#### **Airworthiness Criteria: Airship Design Criteria for Zeppelin Luftschifftechnik GmbH Model LZ N07 Airship**

**ACTION:** Notice of issuance of final design criteria.

**Figure 3: Dihedral Angles for Position Lights**

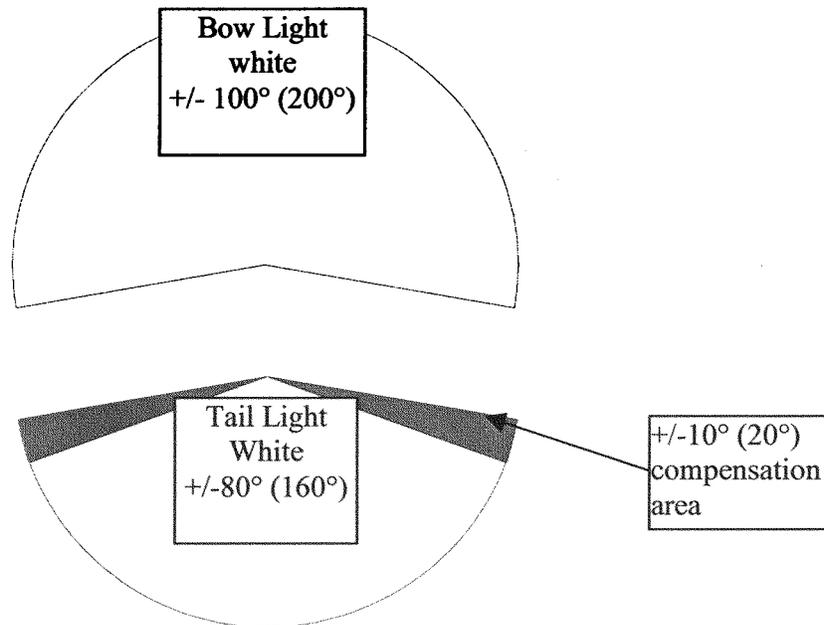
LFLS Section 2498(b) and ADC paragraph 6.25 specify the position lighting requirements for airships. It is not understood why a dispensation should be given for something that can be easily fixed with properly TSO’d LED or similar lighting. ABC had to go through a stringent certification of the lighting on the one model. This was revisited in a new model and the FAA

asked ABC to modify our position lighting by providing two sets of bow lights in slightly different positions to further ensure adequate brilliance in all sectors. It is not understood why any latitude is being given to this basic legal requirement affecting safe navigation of aircraft.

The FAA notes that there is no LFLS section 2498(b) and that the comparable LFLS section to ADC section 6.25 is LFLS section 1385. The only section where an equivalent level of safety to the LFLS lighting requirements was granted by the LBA is LFLS section 1387(b). The LBA granted this equivalency based on what was considered compensating features of the lighting system installed on the LZ N07-100, and the FAA agreed.

LFLS § 1387(b) requires a dihedral angle formed by two intersecting vertical planes making angles of 110 degrees to the right and to the left. LFLS appendix table 10 requires, in addition, a minimum light intensity of 20 cd throughout the dihedral angle. The LZ-N07 system only attains the required intensity over 100 degrees but is still visible from 100 degrees to 110 degrees (left and right) at a reduced intensity. The LBNA granted an equivalency to LFLS § 1387(b) based on the greater dihedral angle coverage of the aft light, +/-80 degrees rather than +/-70 degrees at the specified intensity. This is acceptable to the FAA.

The LFLS § 1387(b) required dihedral angle will be no less than 100 degrees at the intensities specified in Table 10 of the appendix of the LFLS. In addition, the rear light will have an included angle of +/-80 degrees at the specified intensity from Table 10 of the appendix of the LFLS. Refer to Figure 3.
